February 4, 2000

ULNRC-4183

**DOCKET NUMBER 50-483
CALLAWAY PLANT UNIT 1
UNION ELECTRIC CO.
FACILITY OPERATING LICENSE NPF-30
Proposed Changes to NRC Resident Inspector Personnel Office Space
Re: 10 CFR 50.70(b)(2)**

Existing

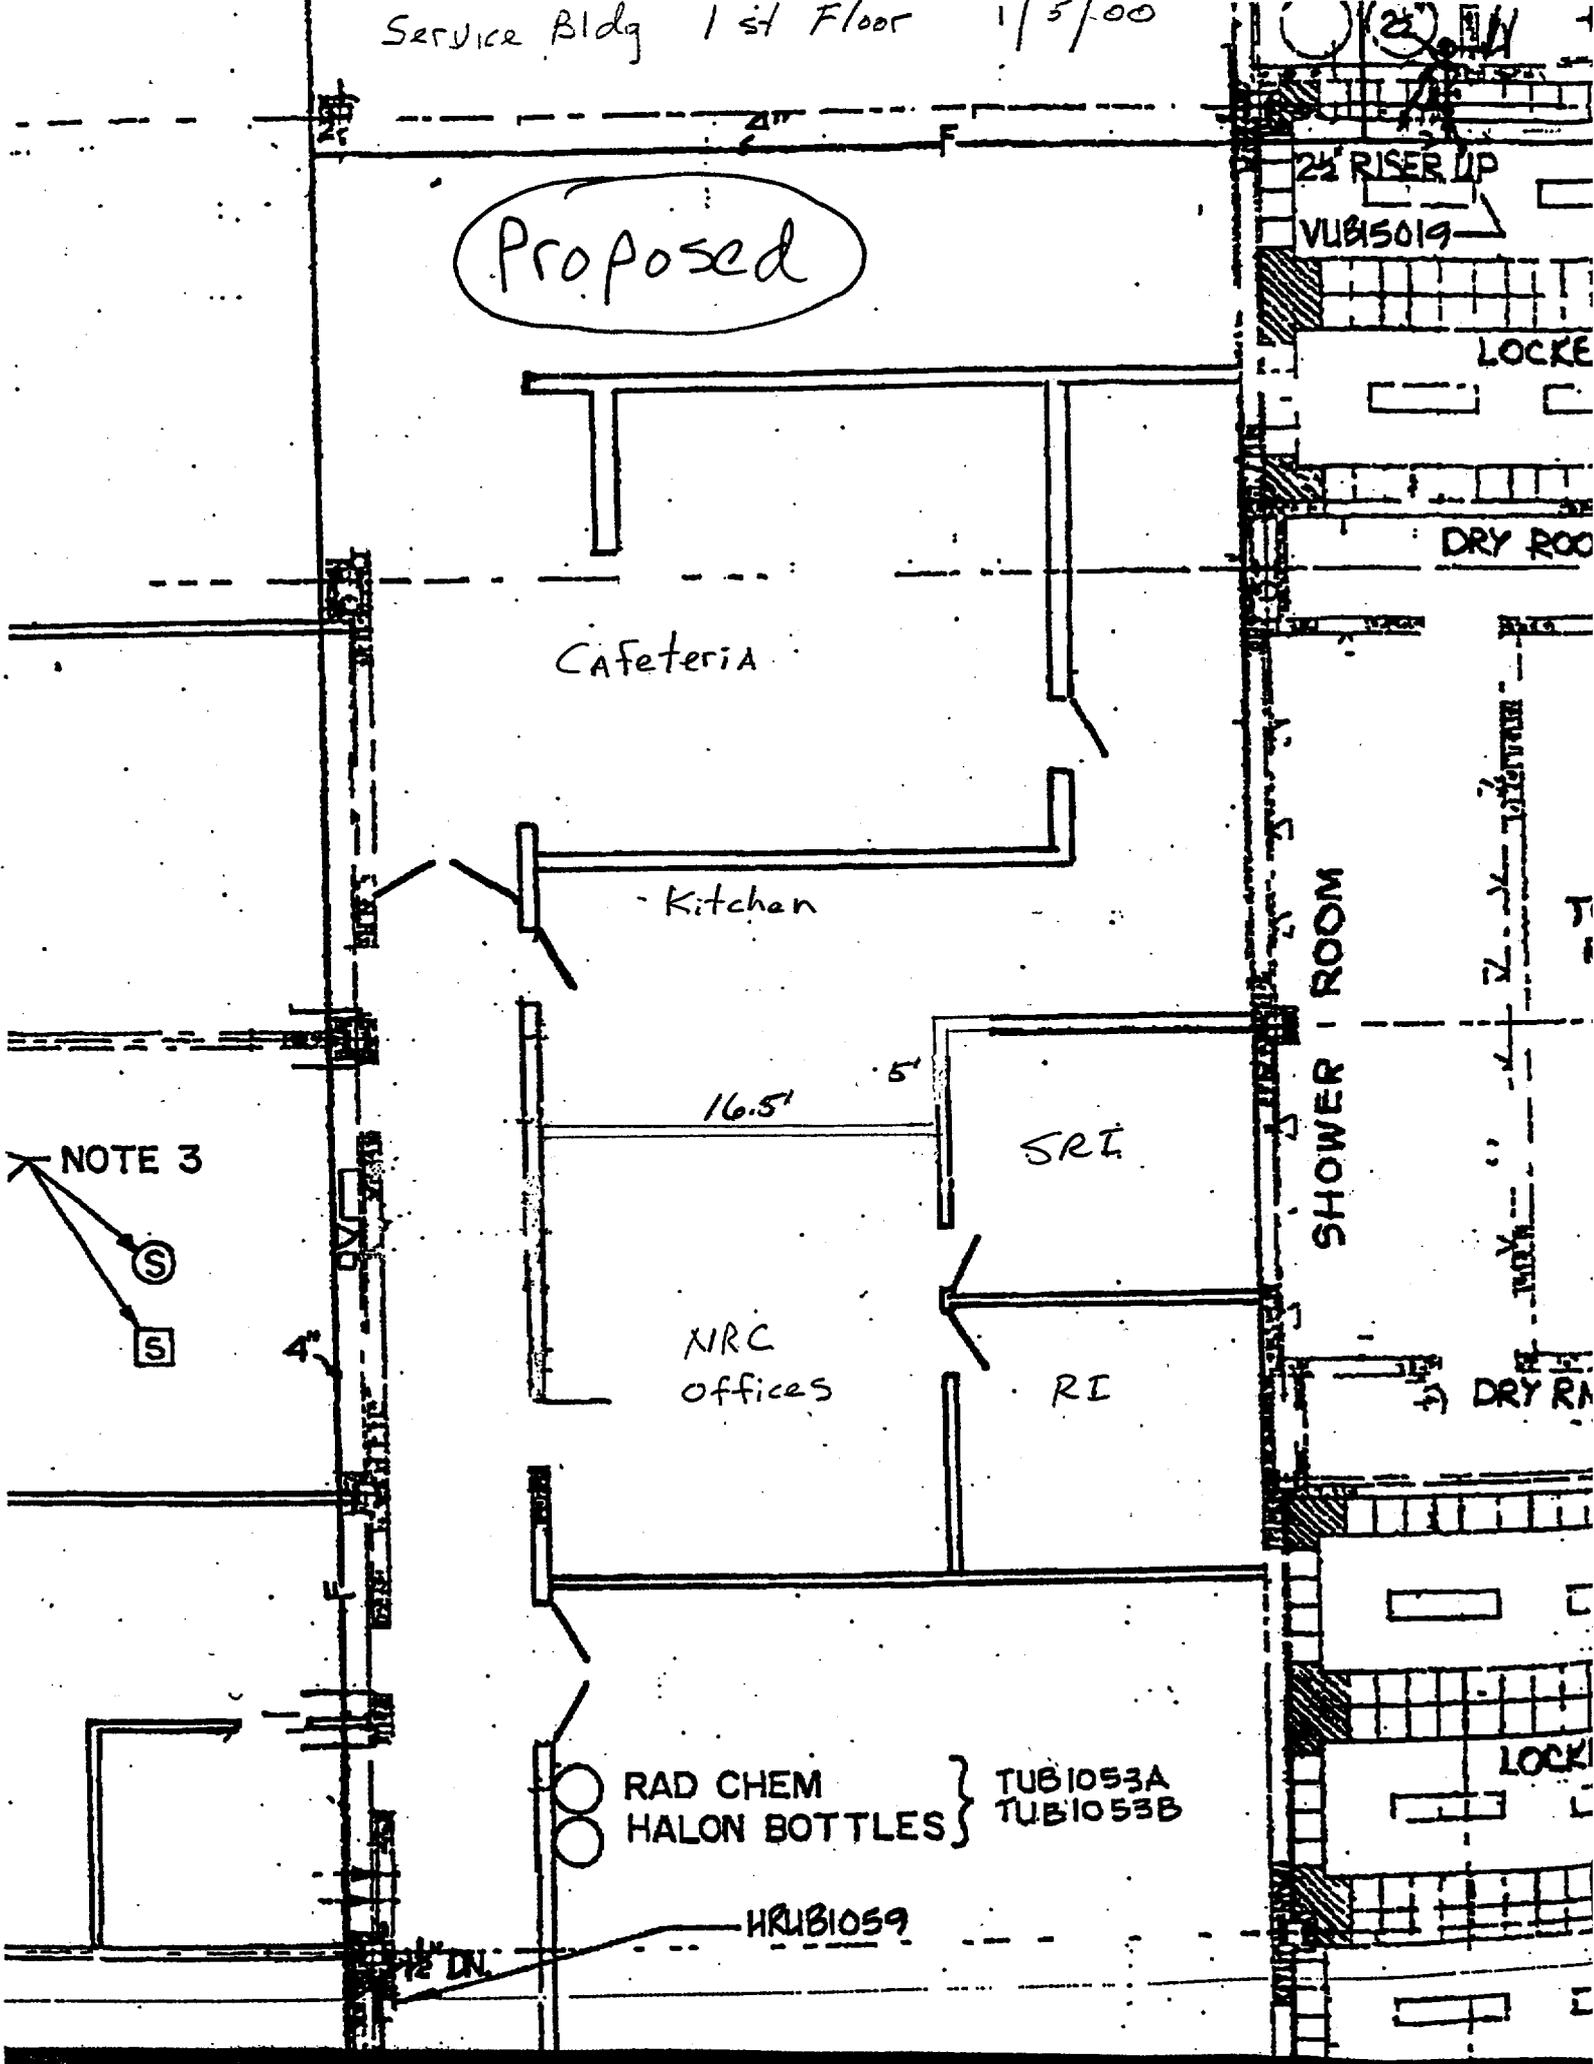
AmerenUE desires to remodel their cafeteria facilities to provide for improved food service, as well as resolve personal safety concerns stemming from overcrowding. In order to accomplish these objectives, it will be necessary to move portions of the wall located between the cafeteria and the Callaway Plant NRC Resident Inspector Office.

The proposed change will result in a total office area of 650 square feet. The office space specifically provided for the Senior Resident Inspector and the Resident Inspector is approximately 350 square feet and is unaffected by the proposed change. However, the general use area will be reduced from approximately 380 square feet to 300 square feet. This area is currently utilized for the part-time NRC secretary and a conference area. While this change is an imposition on the NRC staff, it is desired that the NRC office remain in the Service Building, which is the primary office building at Callaway.

Attached for reference are drawings of the current office area and the proposed change. The drawing scale is approximately 1/8 inch per foot.

Existing

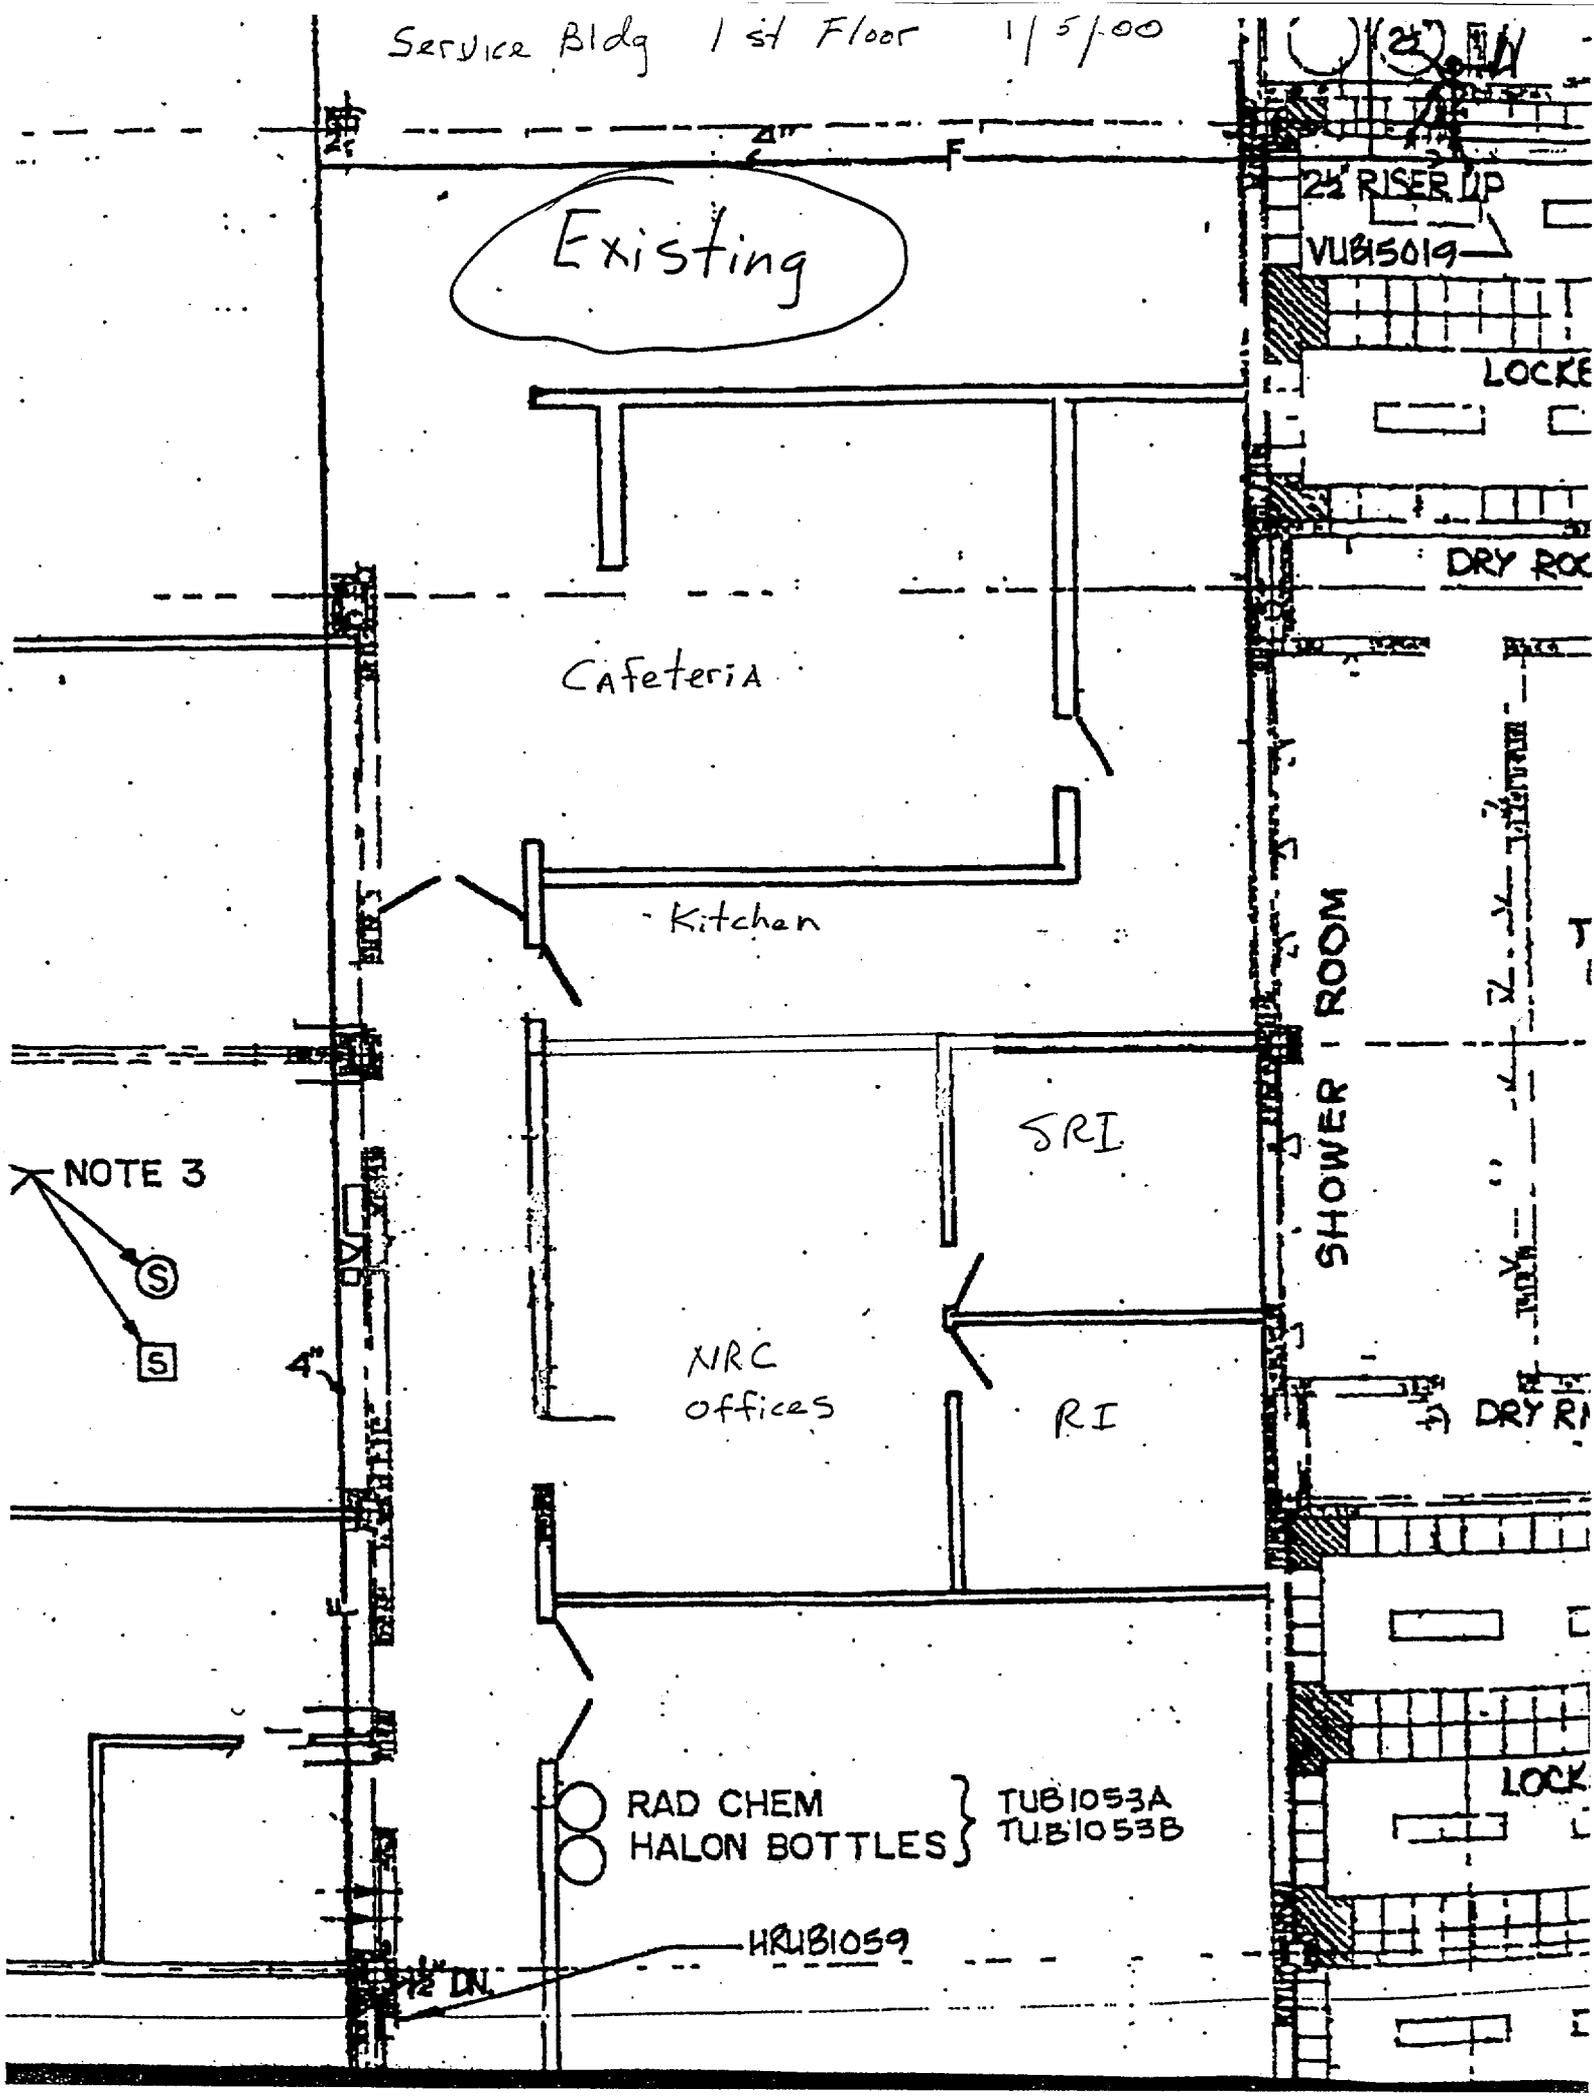
AmerenUE desires to remodel their cafeteria facilities to provide for improved food service, as well as resolve personal safety concerns stemming from overcrowding. In order to accomplish these objectives, it will be necessary to move portions of the wall located between the cafeteria and the Callaway Plant NRC Resident Inspector Office.

The proposed change will result in a total office area of 650 square feet. The office space specifically provided for the Senior Resident Inspector and the Resident Inspector is approximately 350 square feet and is unaffected by the proposed change. However, the general use area will be reduced from approximately 380 square feet to 300 square feet. This area is currently utilized for the part-time NRC secretary and a conference area. While this change is an imposition on the NRC staff, it is desired that the NRC office remain in the Service Building, which is the primary office building at Callaway.

Attached for reference are drawings of the current office area and the proposed change. The drawing scale is approximately 1/8 inch per foot.
